DRAX BIOENERGY WITH CARBON CAPTURE AND STORAGE PROJECT

Drax Bioenergy with Carbon Capture and Storage Project, Selby

Prepared for: Huw Williams
 Prepared by: Andy Tennant
 Date: 01/09/2022
 Case Reference: AA.22.11.13
 Document Reference: AA.22.11.13 TM
 Reviewed/approved by: Terry Dale

Figure 3: Recorded collisions on the M62 east of M62 Junction 36 (2017-2021)

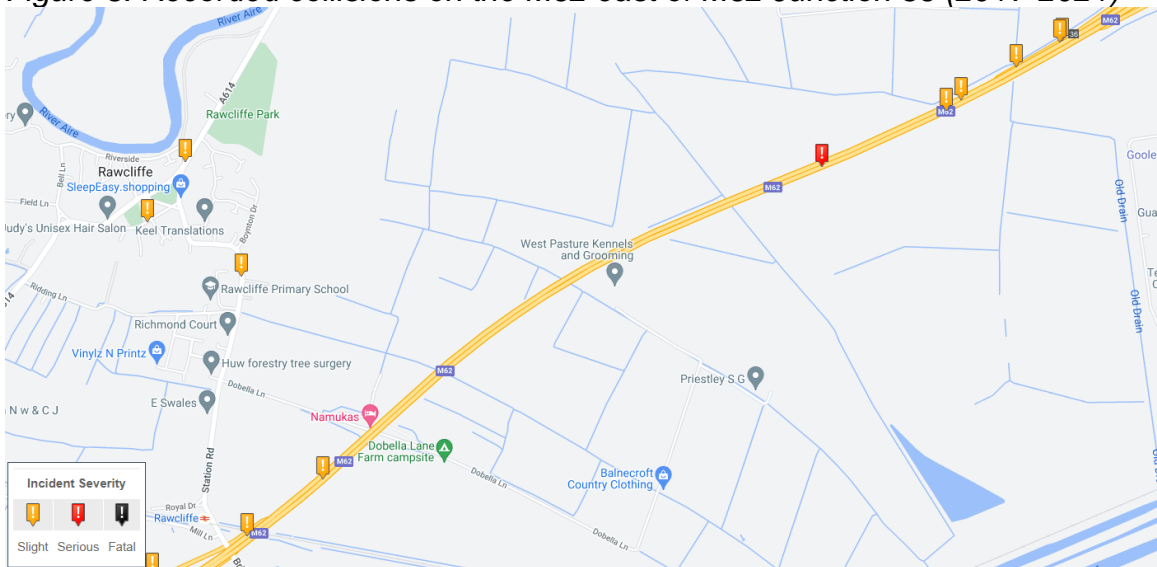
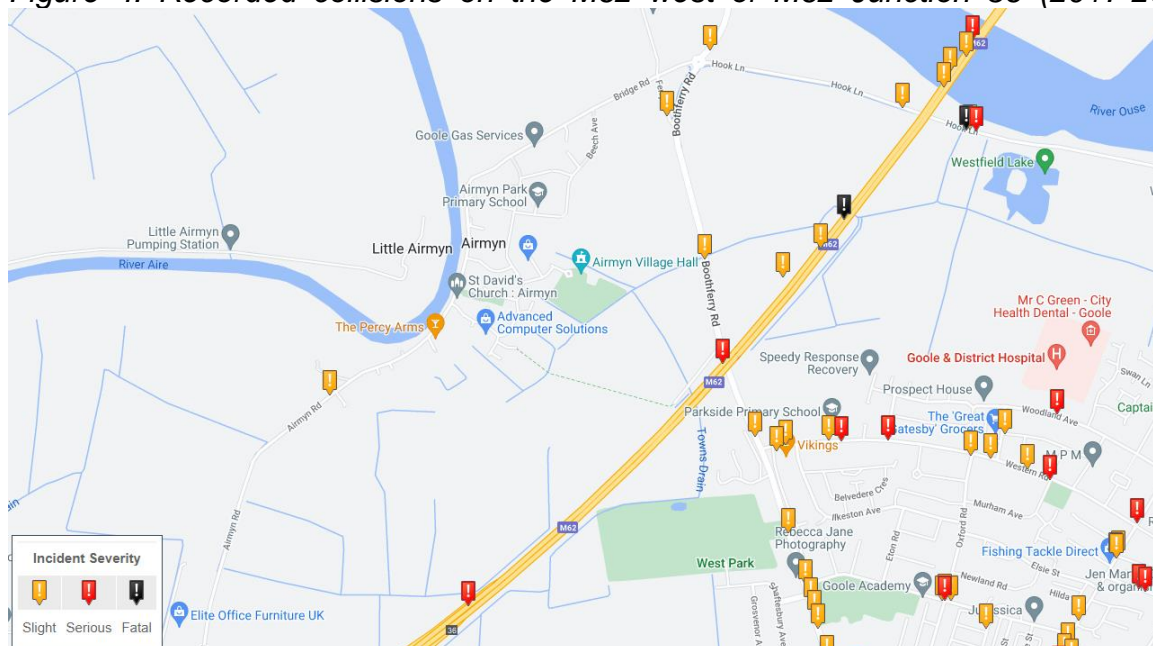
JSJV would recommend that the Applicant present collision data analysis for the period 2015-2019 to ensure that a full 5-year period, unaffected by the covid-19 pandemic, has been reviewed.

JSJV would also note that the analysis provided by the Applicant does not include all recorded collisions on the SRN and a further analysis is required to cover M62 Junction 36 and the M62 mainline east and west of the junction. Where a collision resulted in fatal or serious injury and/or where a cluster of collisions are recorded, JSJV would recommend that the causation factors be considered to identify any pre-existing trends.

Figure 5: Monthly traffic flows in 2018

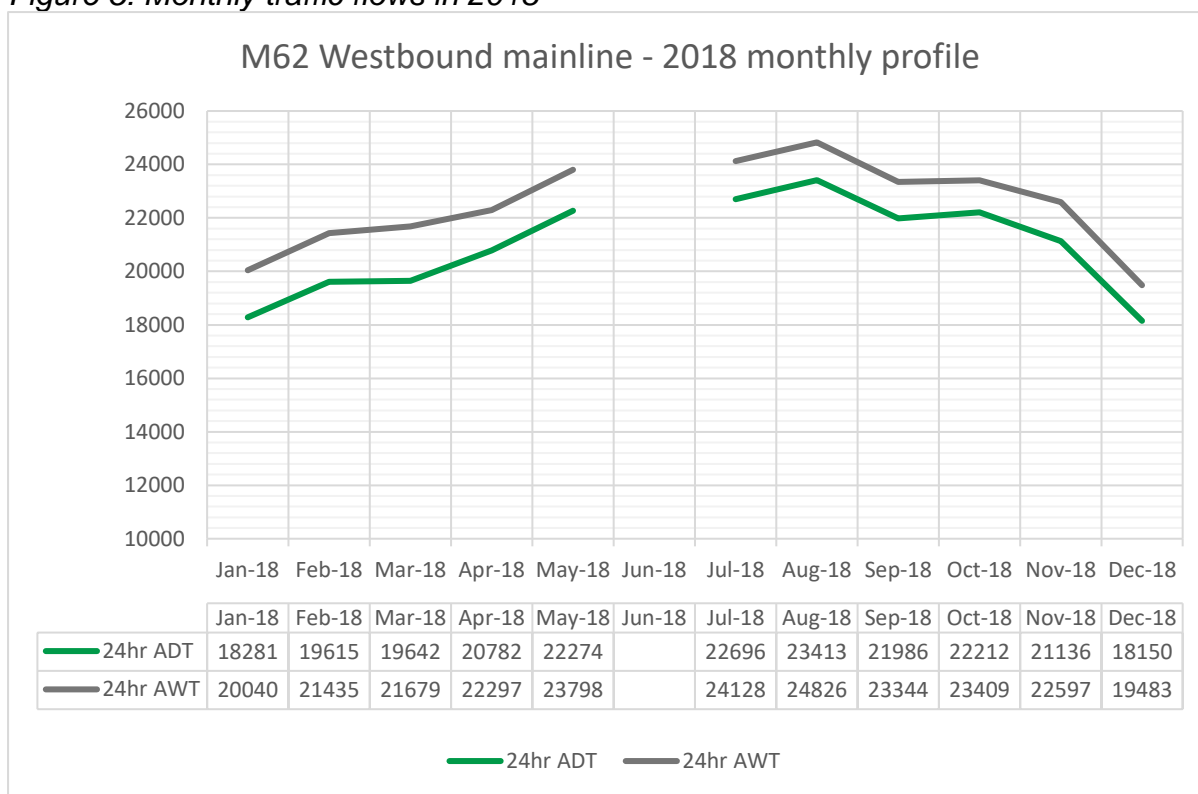
Figure 5 shows that August 2018 experienced the highest traffic flows in 2018 and December 2018 experienced the fewest. In terms of average traffic flows, October 2018 was a fairly average month in 2018.

Figure 6: Profile across the surveyed Thursday and average Thursdays in June/July

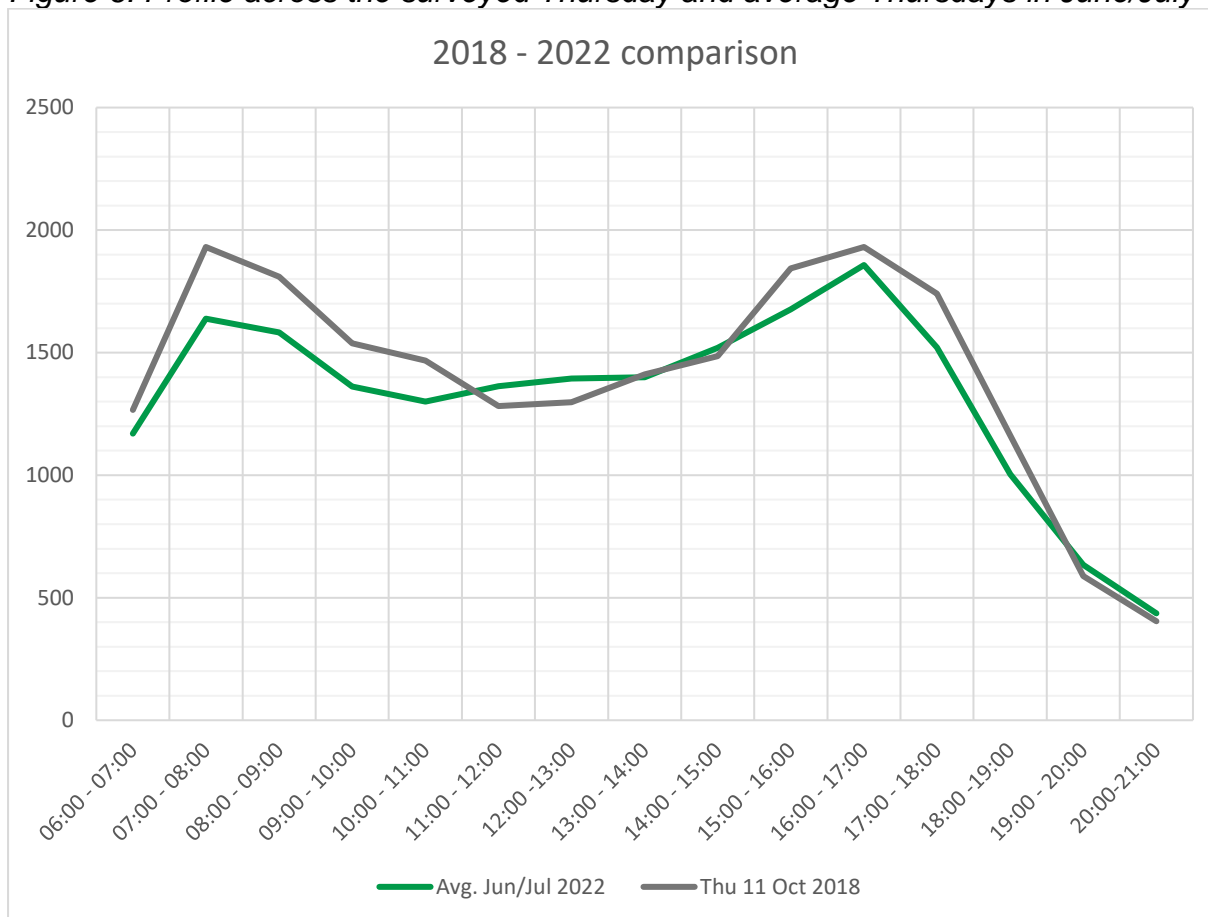
Given the above analysis, JSJV would conclude that the daily traffic profile has not materially changed from 2018 to 2022. We would, however, note that the traffic flows for the morning and evening peak periods have reduced from 2018 to 2022.

Figure 8: Proposed HDV routing

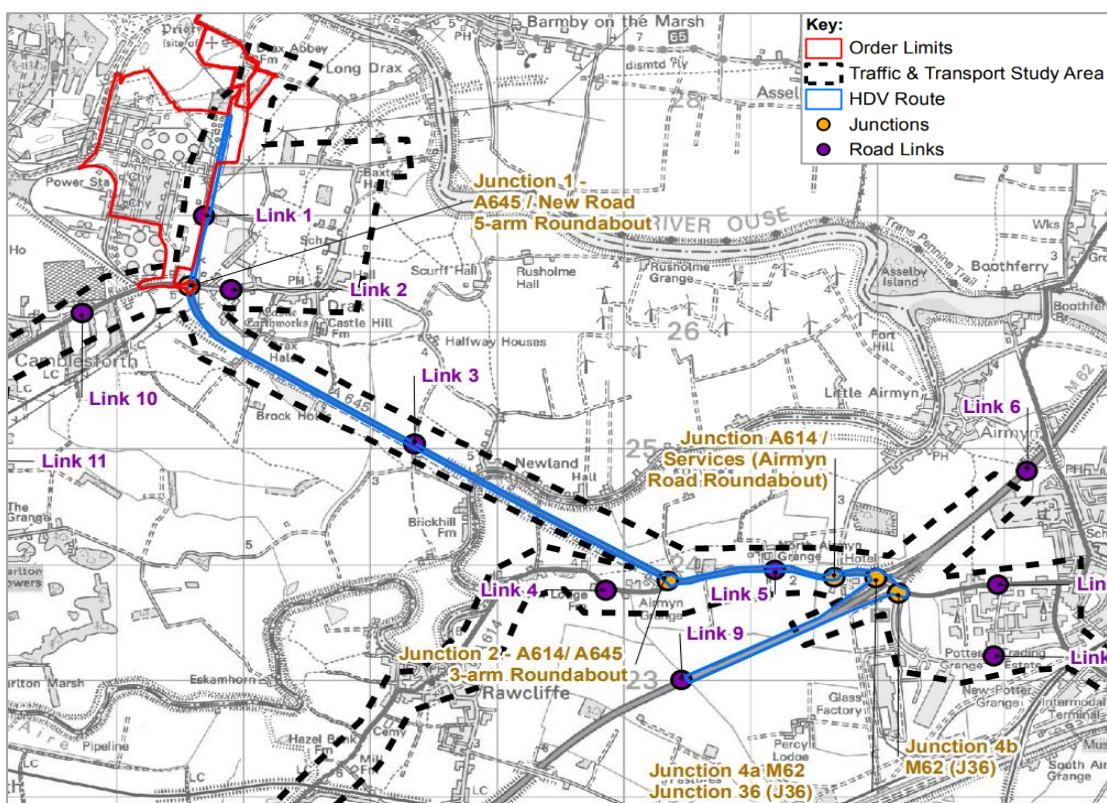
JSJV supports the assumption that 100% of the HDV trip generation will use M62 Junction 36 as this represents a worst-case scenario.

Figure 11: Two-way trip assignment at M62 Junction 36 across the planned schedule for the Option 2 construction plan

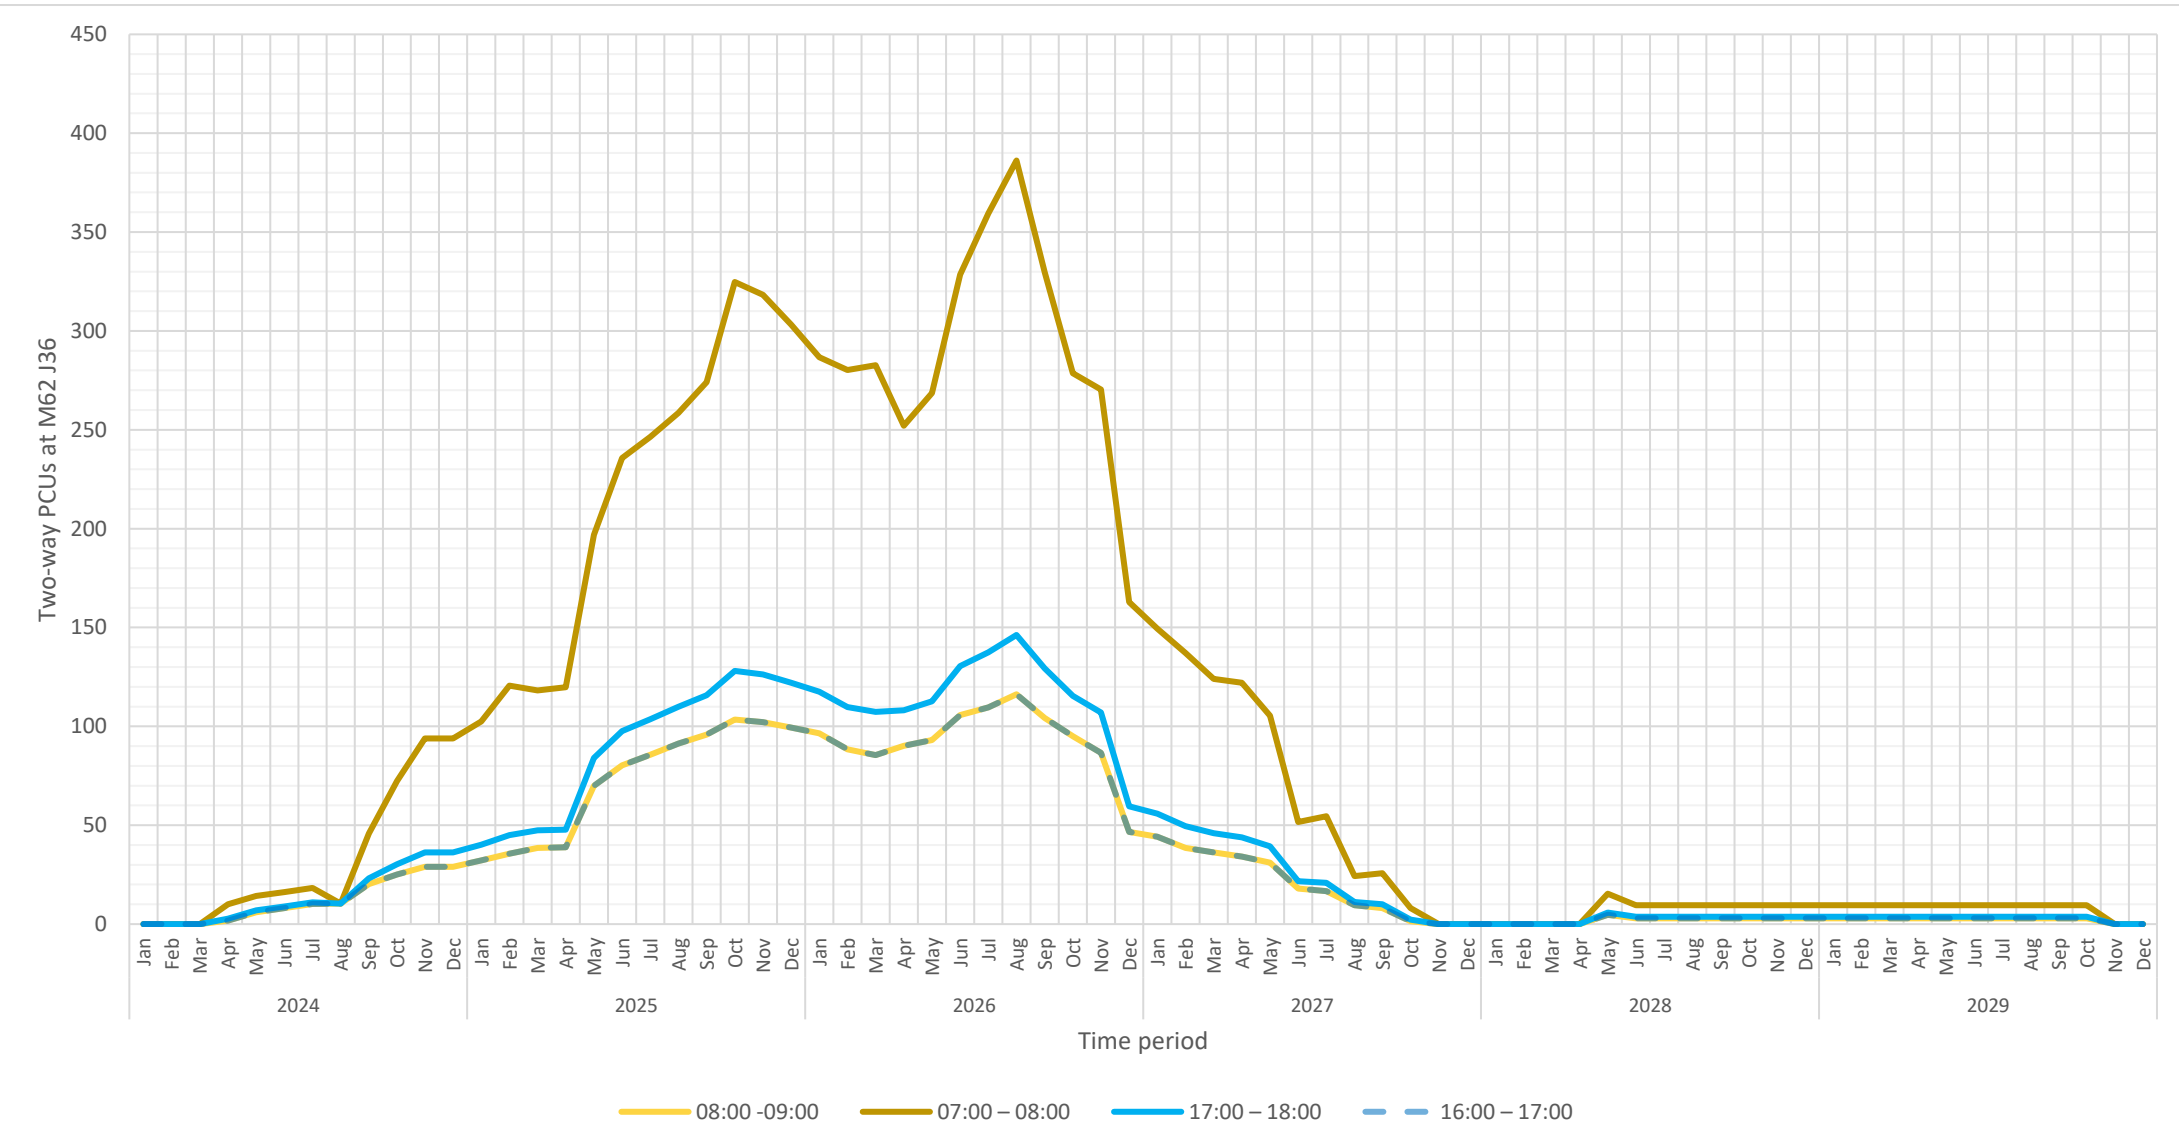
JSJV would reiterate that further analysis is required to assess the SRN peak periods (and, potentially, the corresponding shoulder peak periods).

However, the above figures show that, for 29 continuous months (Jan-25 to May-27), there are over 100 two-way PCUs forecast to use M62 Junction 36 between 07:00 and 08:00.

Figure 12: Two-way trip assignment at M62 Junction 36 across the planned schedule for the Option 1 construction plan

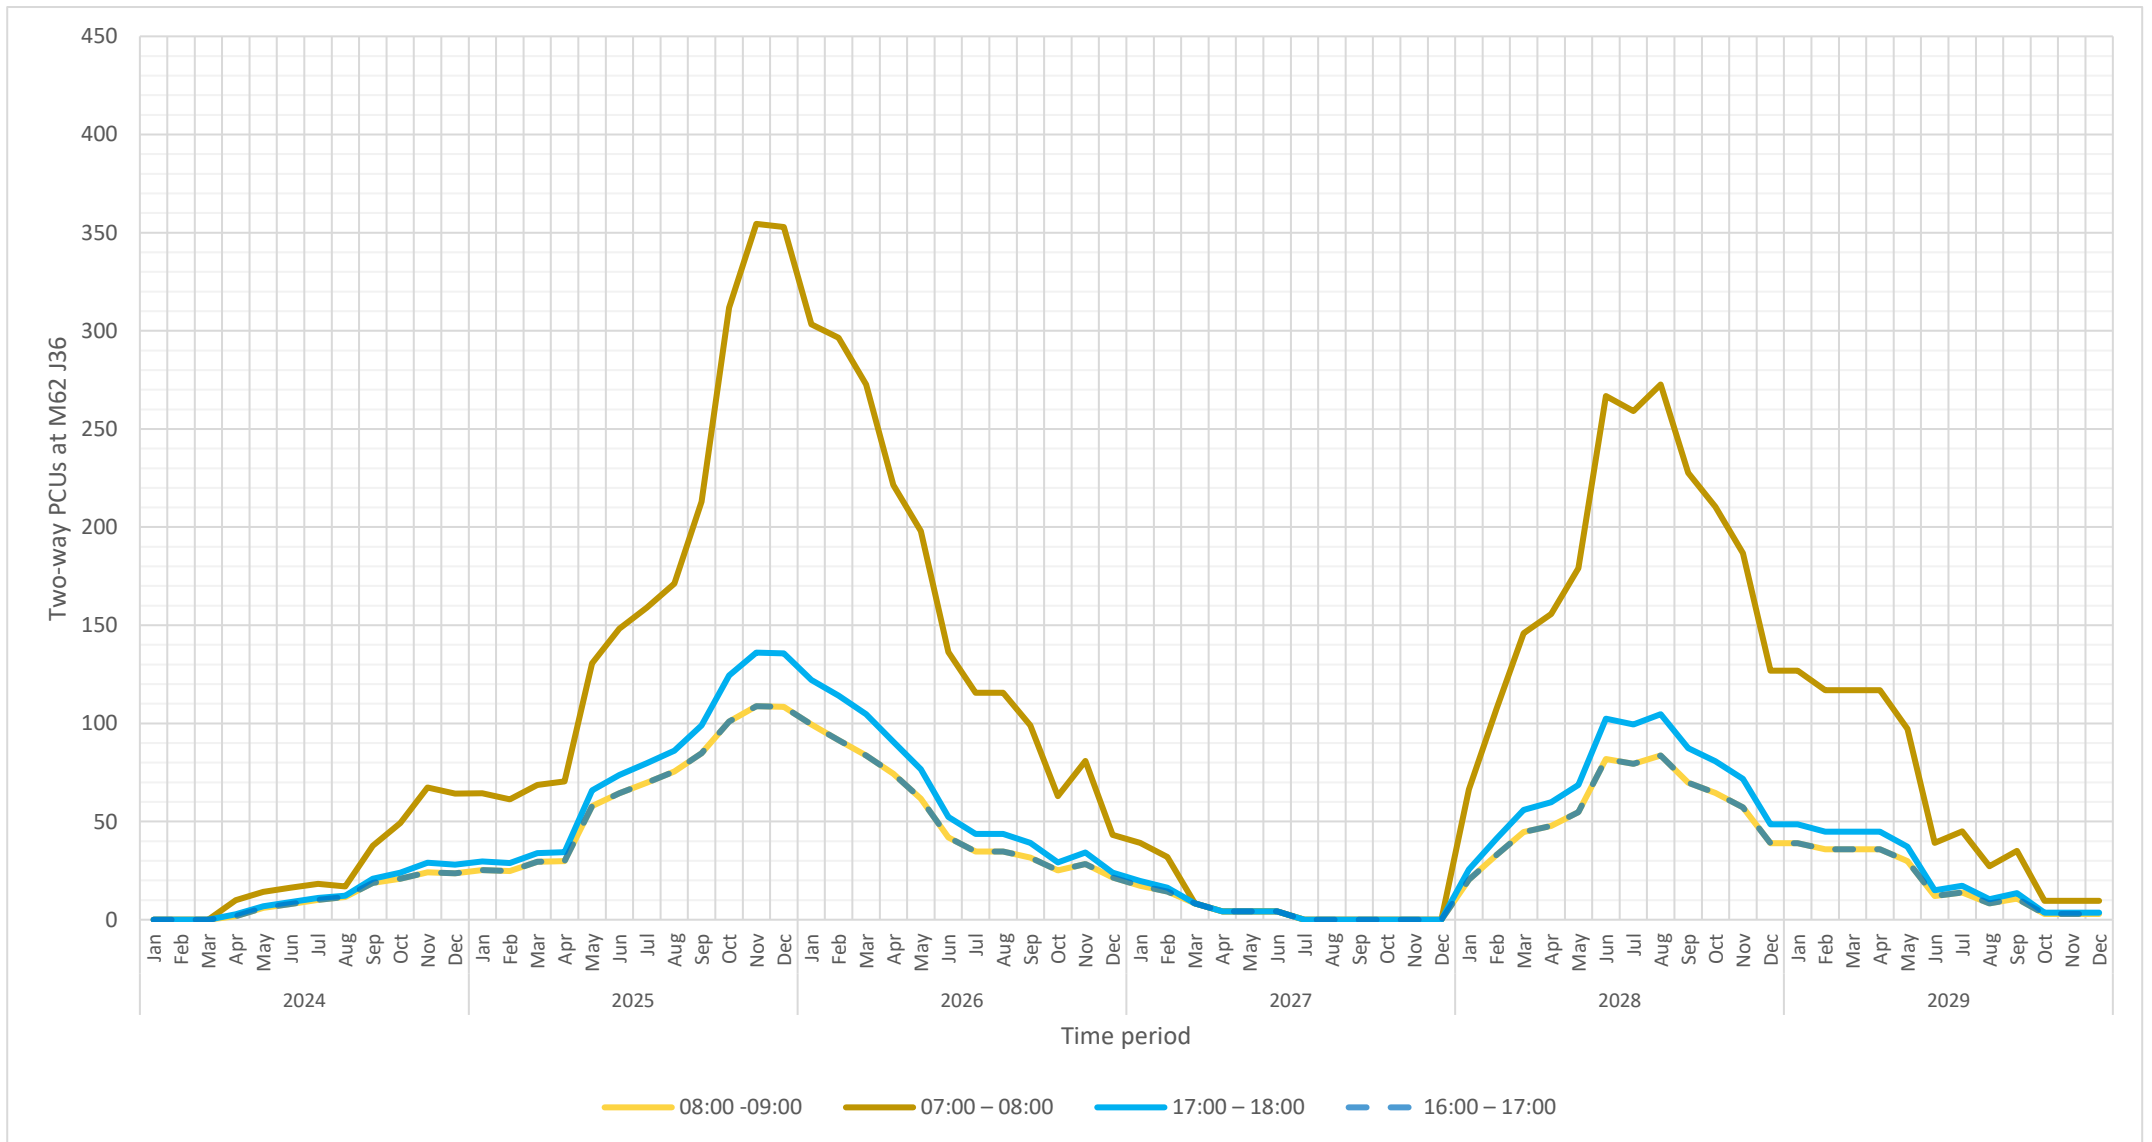
For Option 1 (as shown in Figure 12), there are forecast to be over 100 two-way PCUs using M62 Junction 36 between 07:00 and 08:00 for the following consecutive months:
